ISSUE DATE: 8/17/2001

**ON-SITE SEWAGE DISPOSAL SYSTEM
HOWARD COUNTY HEALTH DEPARTMENT
BUREAU OF ENVIRONMENTAL HEALTH**

SUBDIVISION: Twelve Hills LOT NUMBER: 41

ADDRESS: 14003 Twelve Oaks Court PROPERTY OWNER: ROBERT STEPHENS
Selfridge Builders

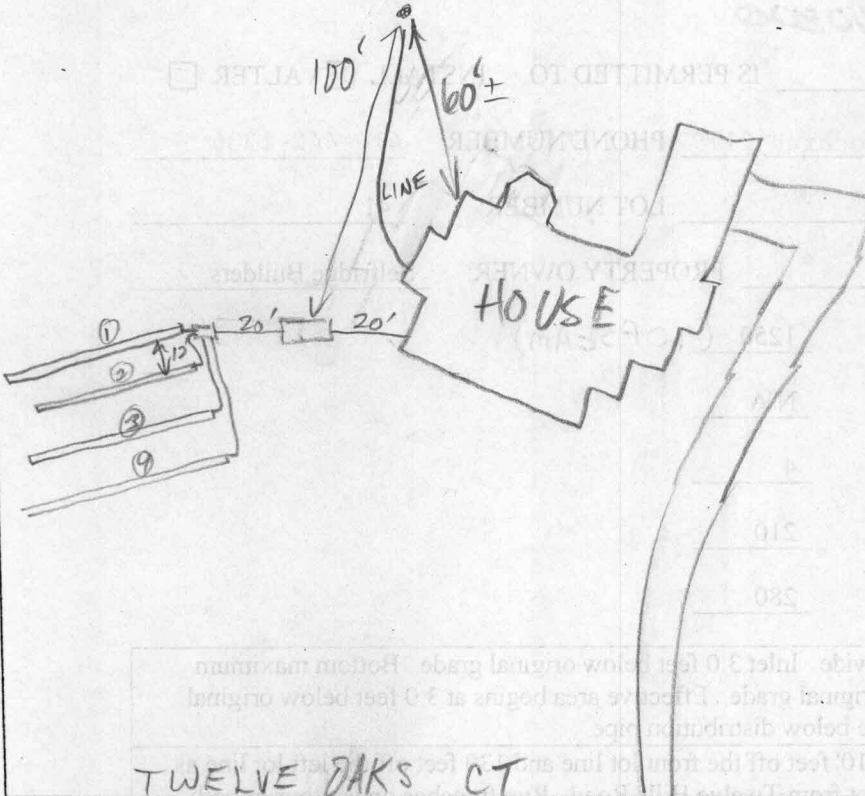
PRE-CONSTRUCTION INSPECTION: Layout - OK to place longer trenches all to south end of septic field
(to avoid 3 central big tree's) RPP 9/6/01

INSPECTION COMMENTS: 9/7/01 S.T., D.B. INSTALLED; NO OTHER WORK (MR)

Trench 2 covered (open @ ends) Trench 3 grouted, filled & prepared OK to cover, Trench 4 open OK to gravel fill
OK to cover all work when finished. (not closed early due to emergency office) RPP 9/11/01
